Brite Lites Product Bulletin

p/n: TLEDPOLA

Description: Polaris IQ LED taillight Insert – CFI models

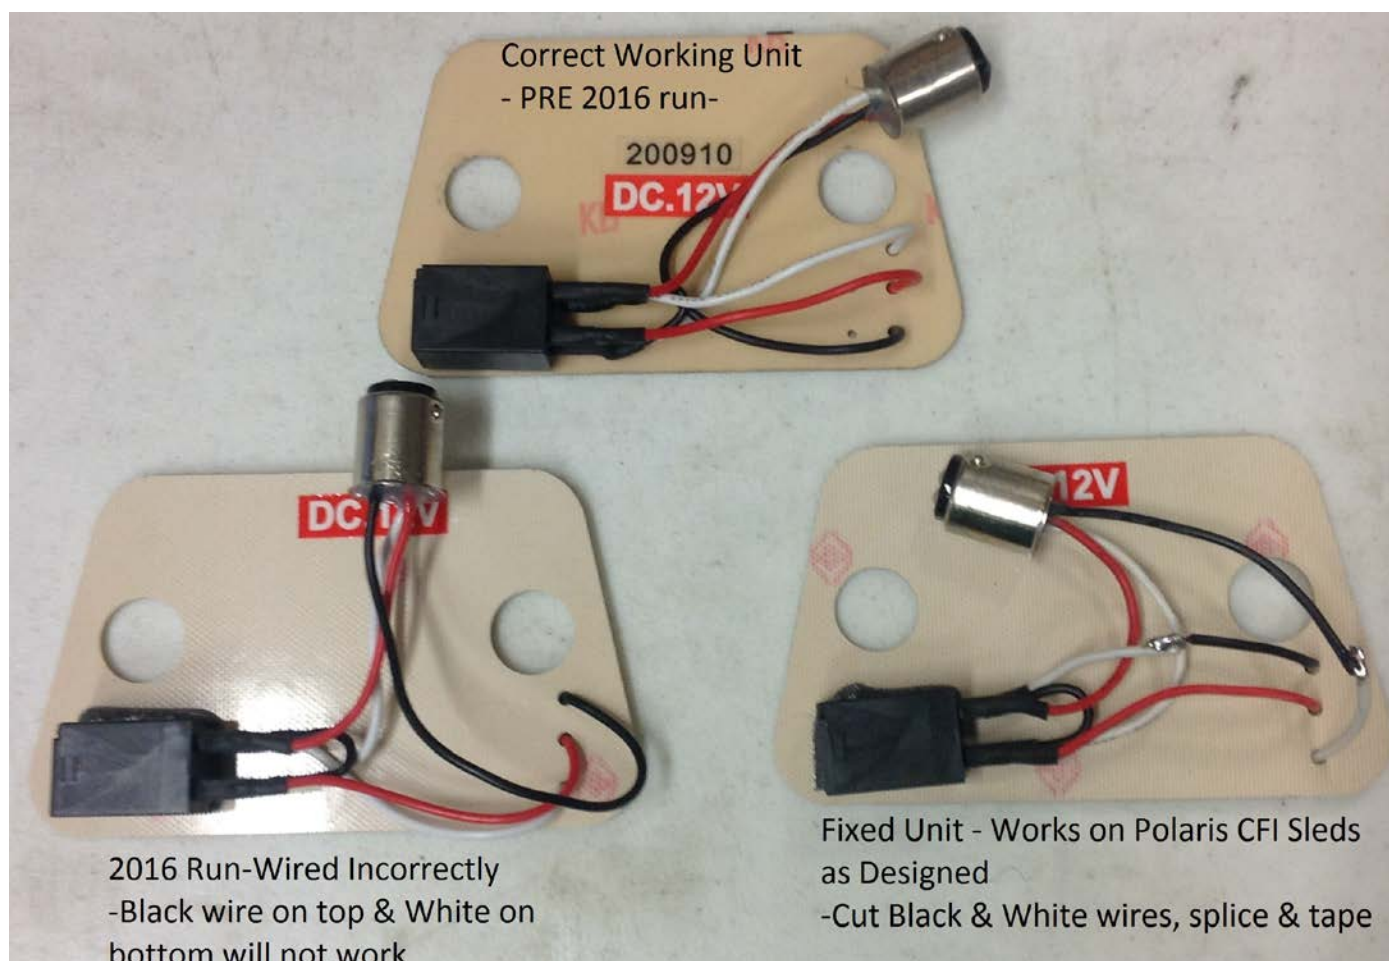
Problem: Current production batch from September 2015 was built with wiring crossed and the unit will not operate on the intended CFI type Polaris snowmobiles. (2007 thru 2014 IQ chassis)

Identification: The parts affected can be visually identified by looking at the back side of the board to see if the Black color wire is located in the upper hole or the lower hole in the PC board. In the picture below, the top unit is wired correctly and from a prior run of units. The lower left corner is a unit produced in September and will not function as wired.

Solution: The fix to make the unit operational as intended is very simple. The lower right unit shows the fix. Just switch the Black and the White wires by either cutting and splicing as shown, or by unsoldering from the board and re-soldering to the board with the Black wire on the lower position, so it looks like the unit in the top picture. Once soldering is completed, exposed wires should be sealed with electric tape or heat shrink tubing.
